CITY OF BLOOMINGTON

June 26, 2013 @ 2:00 p.m.
CITY HALL -
KELLY CONFERENCE ROOM #155

**BLOOMINGTON HEARING OFFICER
STAFF REPORT**

**CASE #: V-27-13
DATE: June 26, 2013**

Site Plan
 V-26-13
 504 E. Hillside Dr.
 Abigail Culbert

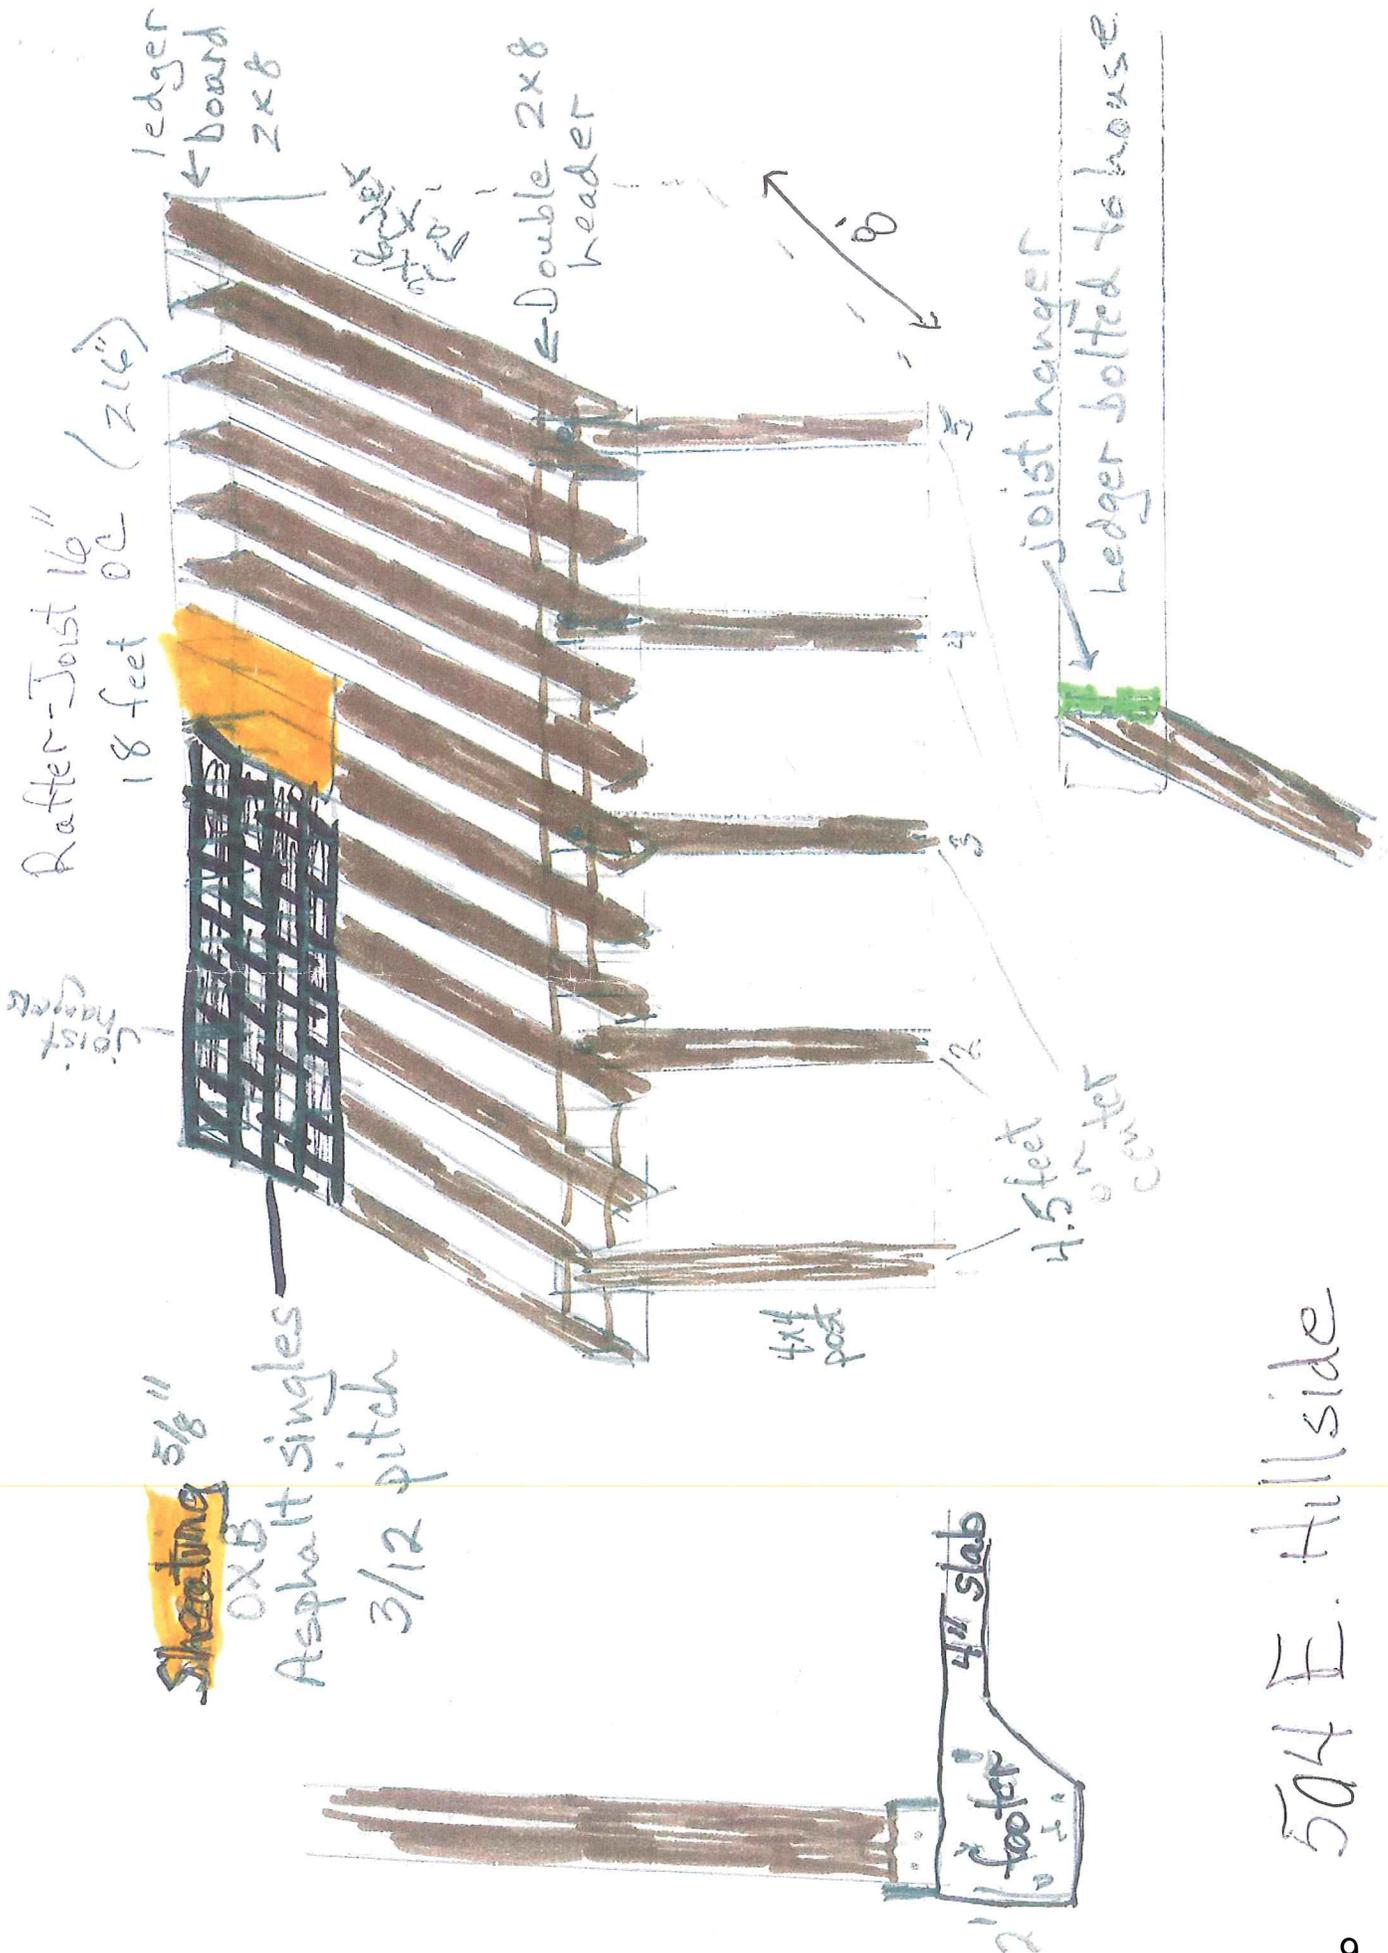
The petitioner is proposing a 144 square foot addition to the rear of an existing single family house. The addition would match the existing eight-foot side setback of the current house. The proposed addition is a screened porch that provides interior access to the basement. In the RM district, the Unified Development Ordinance requires a minimum side setback of fifteen feet. The petitioner is requesting a variance from the required fifteen-foot side setback to construct the addition with an eight-foot side setback.

STAFF FINDING: Staff finds that the existing side setback and single family use present practical difficulties in the building of an addition which meets the requirements of the UDO. The required fifteen foot side setback is based on multi-family structures and uses. If the property were in a single family zoning district, it would meet the minimum required side setback. In the Residential Single Family (RS) district, a minimum of 8 feet is required. In the Residential Core (RC) district, a minimum side setback of six feet is required. The petitioner is proposing to improve the property by providing interior access to the basement, and the existing door to the basement is along the east side of the house. This variance will relieve practical difficulties in the use of the property.

RECOMMENDATION: Based upon the written findings above, staff recommends approval of this petition with the following condition of approval:

1. A building permit is required prior to construction of the addition.

The Park on Morton
Swimming Pool Location
Scale 1:20

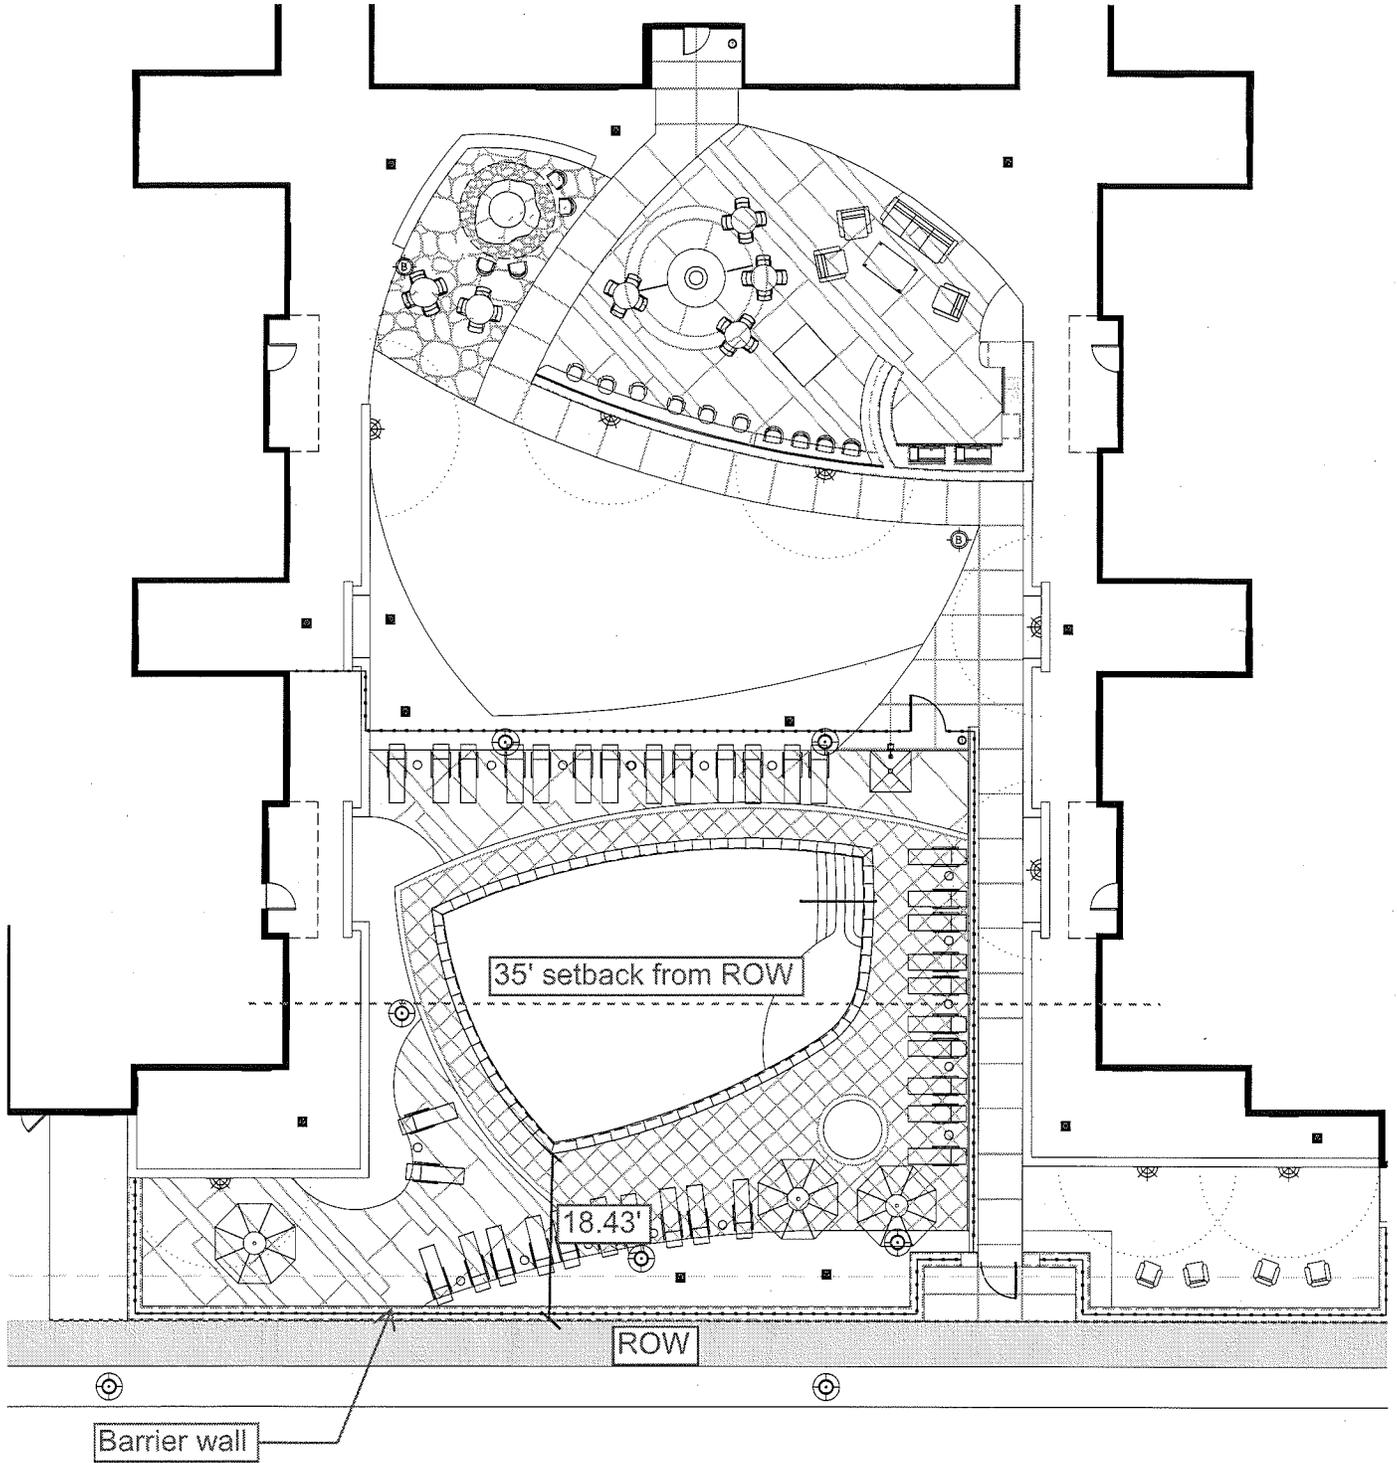
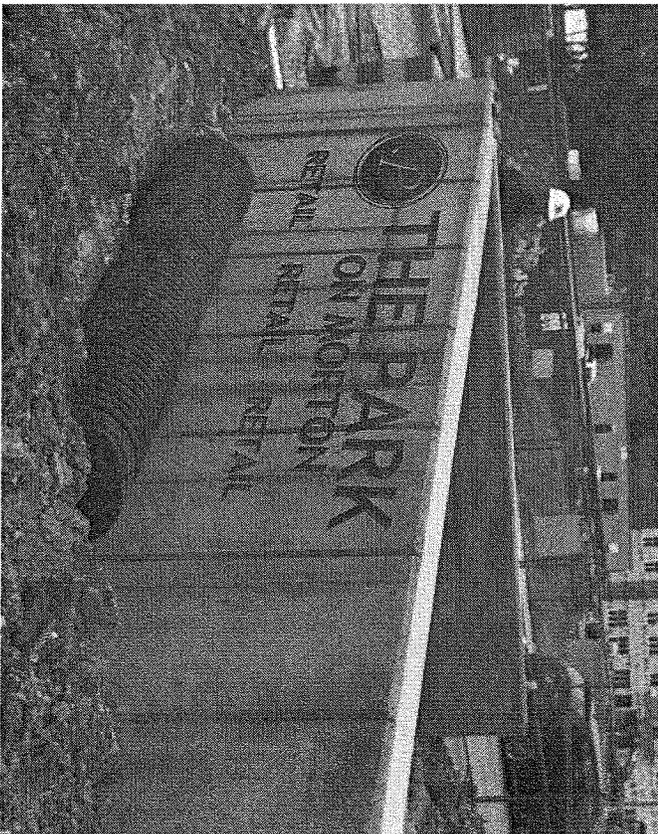
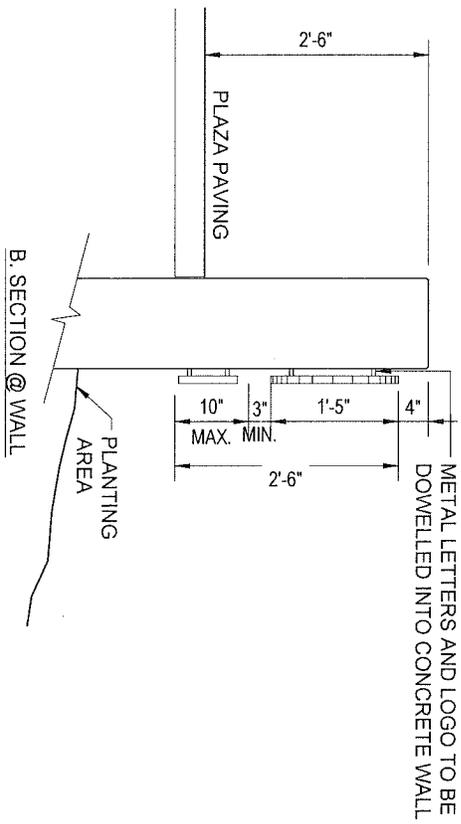
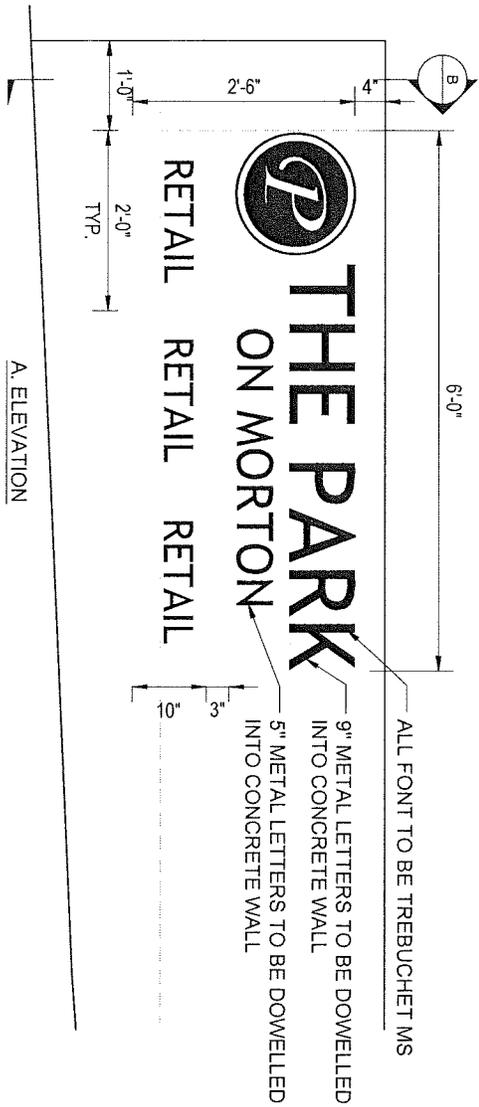
One of the structures on the property includes 100 units and 288 bedrooms and a structured parking garage. This building located at 310 W. 12th St. has a large courtyard in which the petitioners are proposing to install a pool to utilize the southern exposure. The pool is raised above street grade and will be screened from the street with decorative retaining wall. The UDO requires that pools maintain a minimum 35 foot setback from the street right-of-way. The proposed pool is only approximately 18 feet from the right-of-way, therefore a variance is required. This requirement was written with single family homes in mind and intended to disallow pools from being placed between the home and street. The proposed pool is located behind the front of the building and is screened from street view. The pool was added to the courtyard design to include an additional amenity for the development as a whole. Staff has no concerns with the requested setback variance and finds it to meet the variance criteria.

STAFF FINDING: Staff finds peculiar condition in design of the courtyard. The UDO would require the pool to be placed approximately 17 feet further to the north. This would create less sunlight for the pool. The intent of the requirement was to disallow pools to be placed in front yards. Many residential setbacks are 25 feet from the front right-of-way line with a 35-foot pool setback, thus placing the pool approximately 10 feet behind the front of the structure. The adjacent building is, by UDO requirements, placed near the right-of-way line. The pool is approximately 15 feet behind the front of the building. Because pools need access to sunlight for heating and maximum enjoyment, this would limit the practical ability to build a pool associated with a downtown lot. Approval of this variance will allow the petitioner to create a much desired residential amenity for residents of this building and the adjacent development, while still providing screening from the street and an appropriate urban streetscape for the building.

RECOMMENDATION: Based on the written findings above, staff recommends approval of V-27-13 with the following condition.

V-27-13
Freestanding Sign

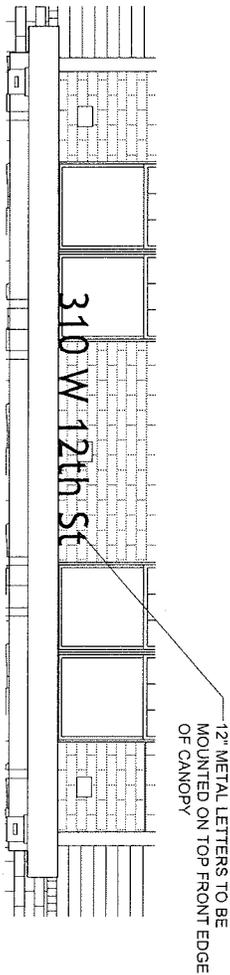
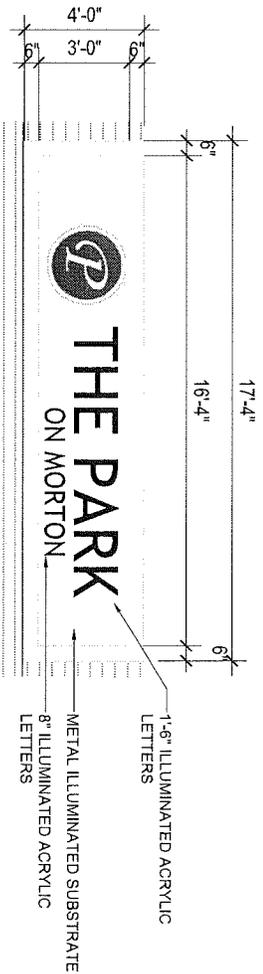
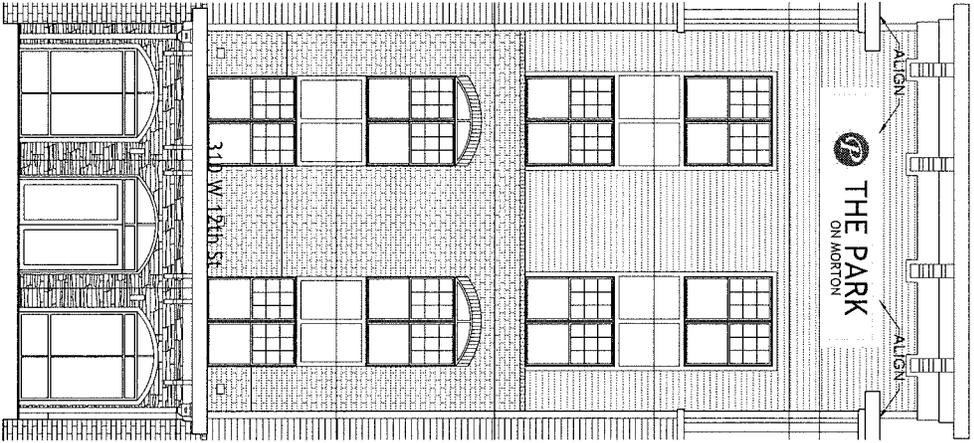
The petitioners are also seeking an approval for one freestanding sign for the overall development. The UDO does allow this site a freestanding sign of 15 square feet and 4 feet in height. However, the petitioner is proposing to place this signage on an existing wall that protects an outdoor patio area. In calculating freestanding signs, the UDO calculates the entire freestanding structure. The petitioner is seeking an approval to calculate this sign using only the area of the identifying lettering and logo.

Staff finds peculiar condition in the large size and unified nature of the development. Unlike most downtown developments, this development includes several lots and multiple buildings that makes on-site identification more important than most downtown projects. This is a very large property and the proposed signage will assist in the efficient identification of the leasing office and the main entry of the large residential structure. Staff finds that the existing wall at the intersection of 11th and Morton was constructed to the adjacent patio area and was not designed with the signage specifically in mind. The wall is already in place and will not be impacted by the signage. The lettering and logo for the freestanding sign is within the maximum 15 square feet of signage and will serve a large mixed-use development.

1. No other residential signage is permitted. All other non-residential signage must meet current UDO standards.

V-27-13
Leasing Office sign

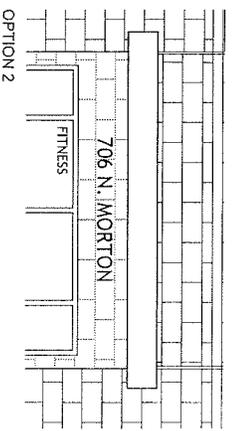
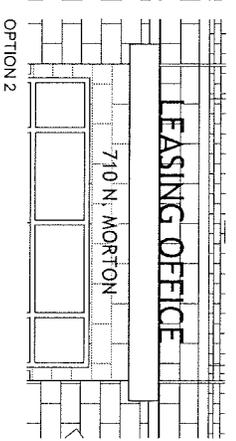
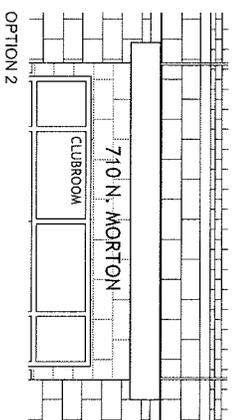
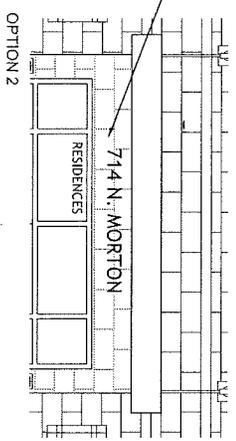
mixture of units. The proposed sign package would allow two residential signs, one of 36 square foot to identify the development and highlight the main entry of the large residential structure and one small sign of 10" channel letters that would identify the on-site leasing office. This use is considered residential and does not automatically qualify for a commercial sign. Staff finds these two signs to be a reasonable sign package that will allow for a small amount of signage to direct visitors and prospective residents to the most highly trafficked entry points. Staff finds these signs to improve on-site flow and to be reasonably sized with respect to the very large nature of the development.

Staff finds no injury with the signage request. The proposed sign package is very small and includes a minimal amount of signage for such a large site. The leasing sign will have no more impacts than potential commercial offices within the same building.
